STAFF REPORT  
COTTAGE GROVE VILLAGE CENTER TENTATIVE SUBDIVISION  
FIVE-LOT  
MSS ENGINEERING  
SUBDIVISION (S 1-22)  
March 16, 2022

**EXHIBIT A:  
MEMO**

**Subject: ENGINEERING COMMENTS FOR S 1-22 (COTTAGE GROVE VILLAGE CENTER – CG VILLAGE CENTER, LLC)**

**P-210**  
# 2 OF 3 SHEETS

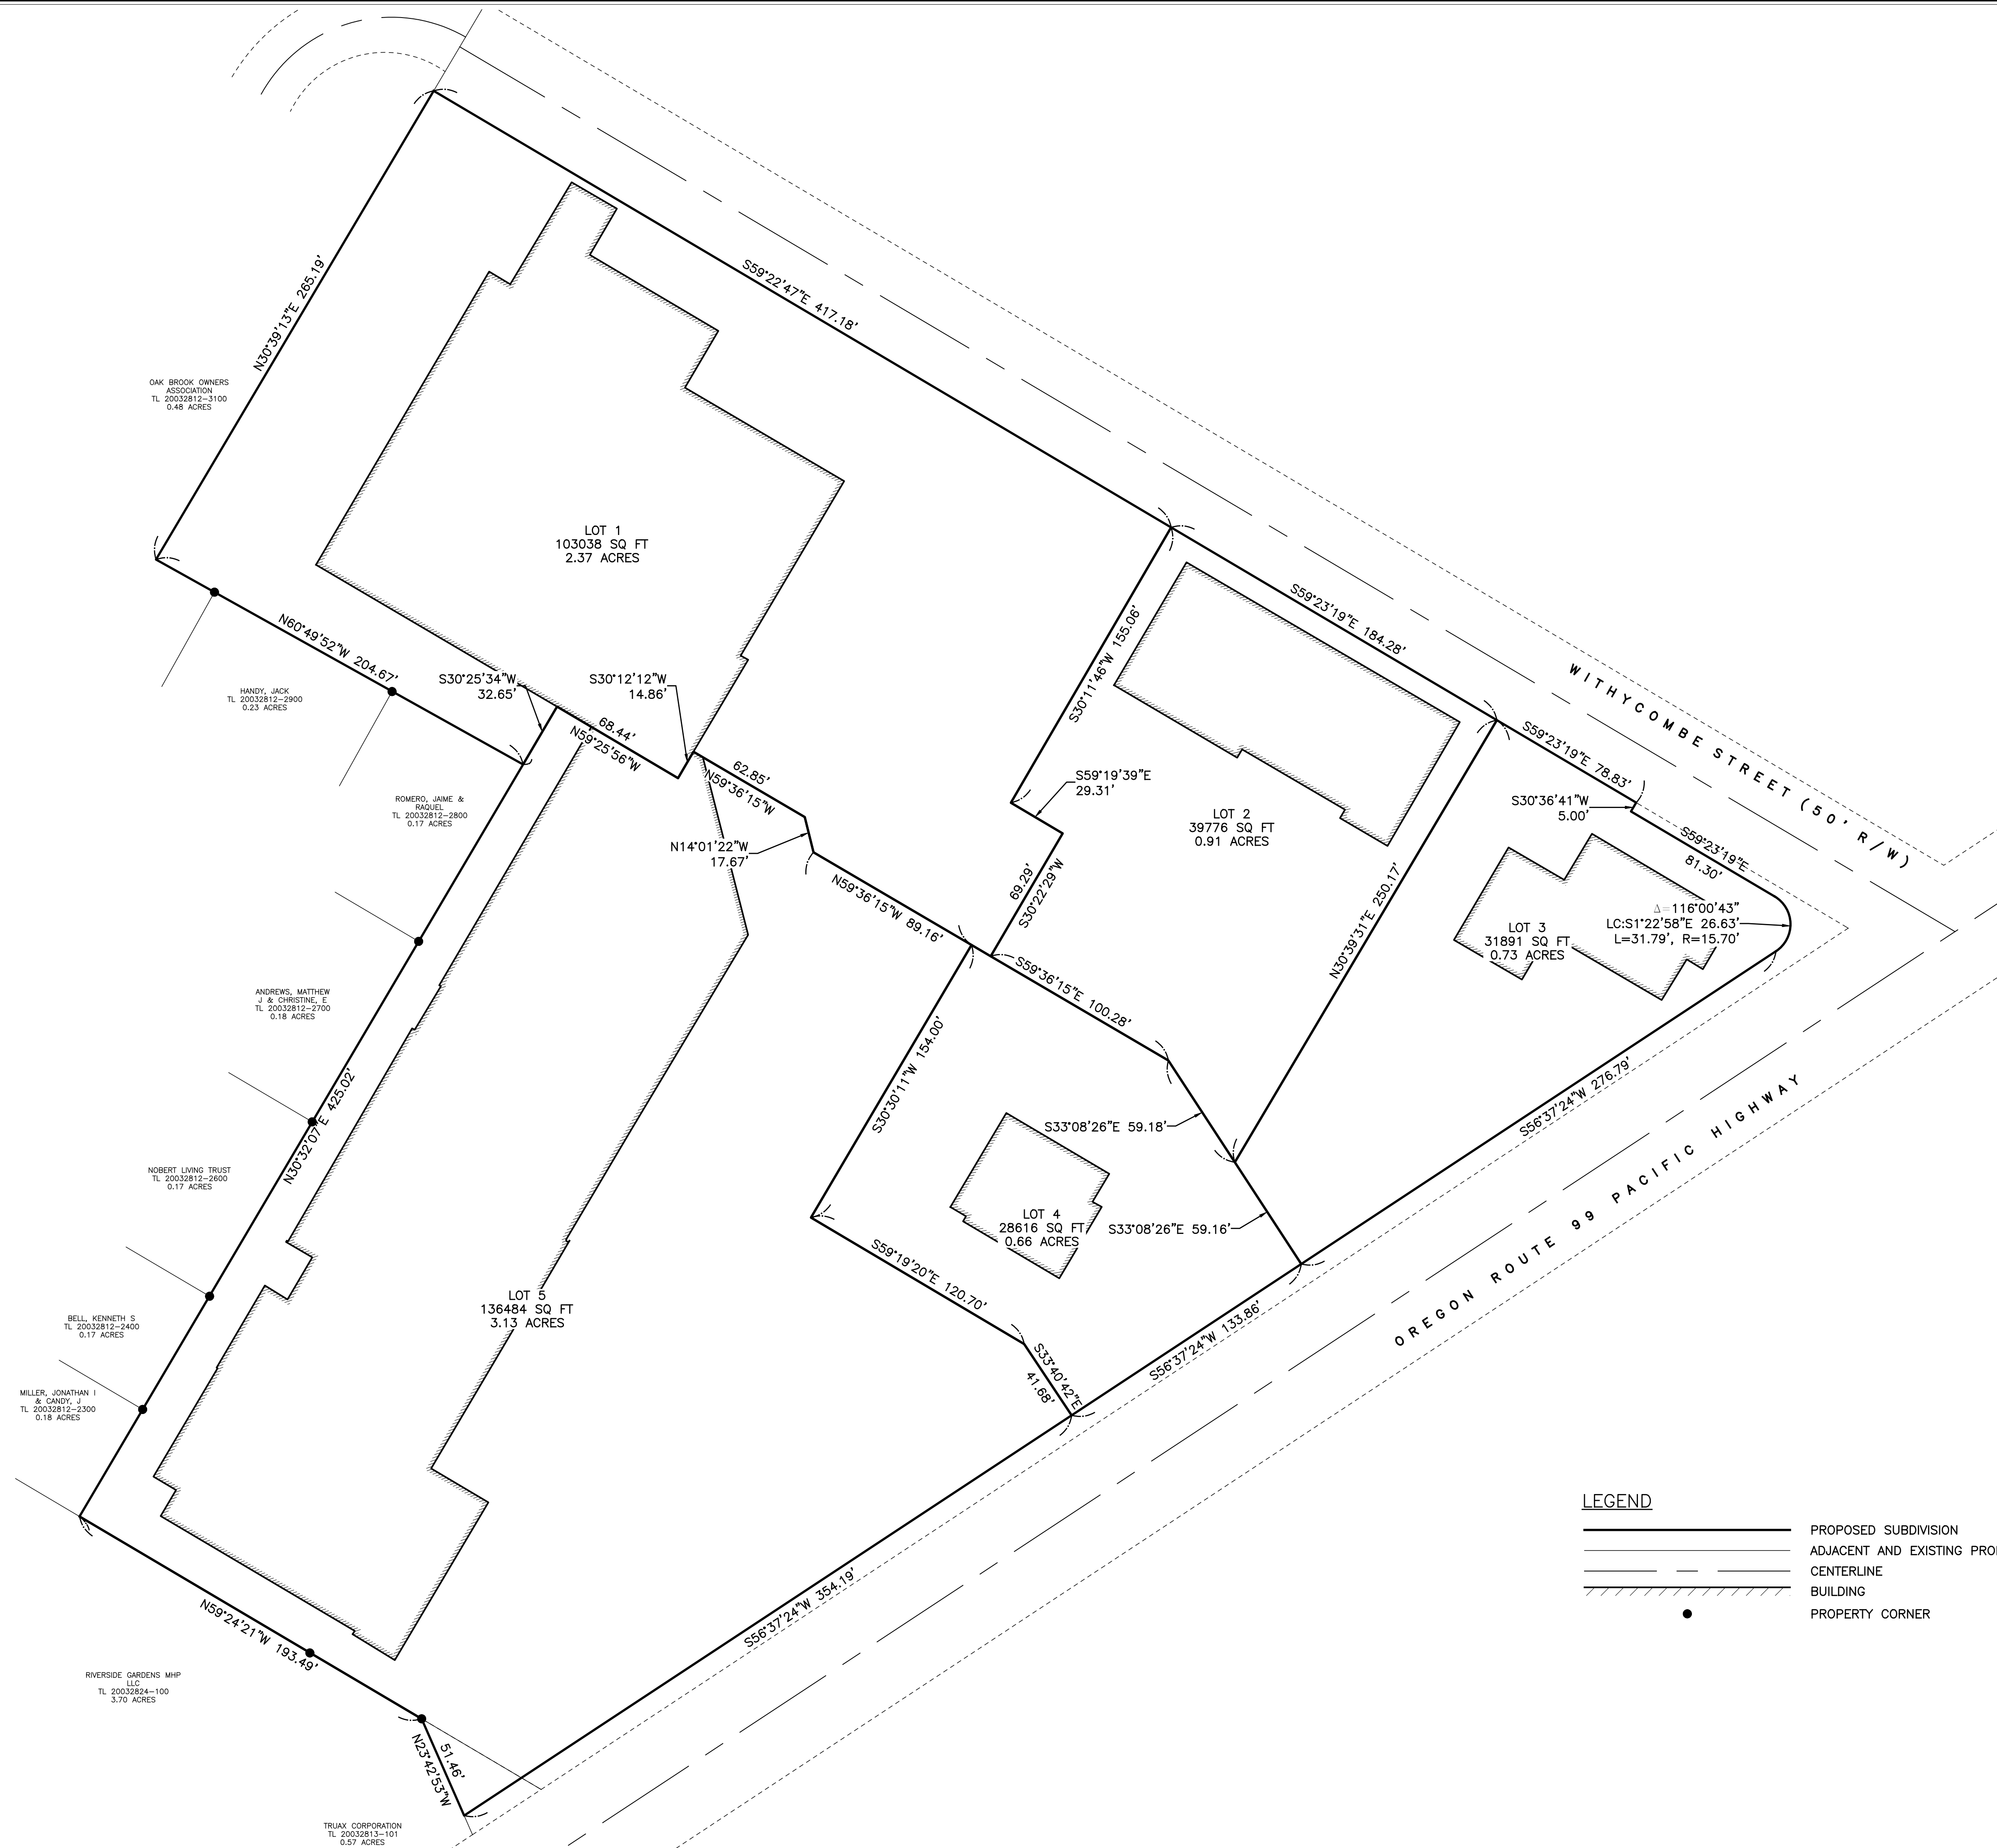
- Developer, Property Owner or Surveyor shall provide the City of Cottage Grove with a Mylar copy of the filed plat for the City’s records.
- Question for the Developer and Surveyor of Record – Does a blanket easement need to be created for Ingress/Egress of vehicles/pedestrians? I did not see any language on this particular subject.

- Is there an existing agreement or will a new agreement be developed for maintaining paved parking areas? Utilities were covered very well.
- Please label street names according to the City Municipal Code. East – West roads have a suffix of Avenue except for Main Street. North – South roads are Streets. So Withycombe should be an Avenue.

- City staff has witnessed severe ponding on Lot 5 during heavy rain events. Prior owners of the property attempted to correct this problem. New owners may want to investigate the problem further as mentioned in the project narrative.

7. The proposed access and maintenance easement benefitting all proposed parcels shall be provided to the City at time of Final Plat review.
8. Fire Department access standards shall be maintained with minimum 20' paved width and 13'6" vertical clearances as required by 2014 Oregon Fire Code.
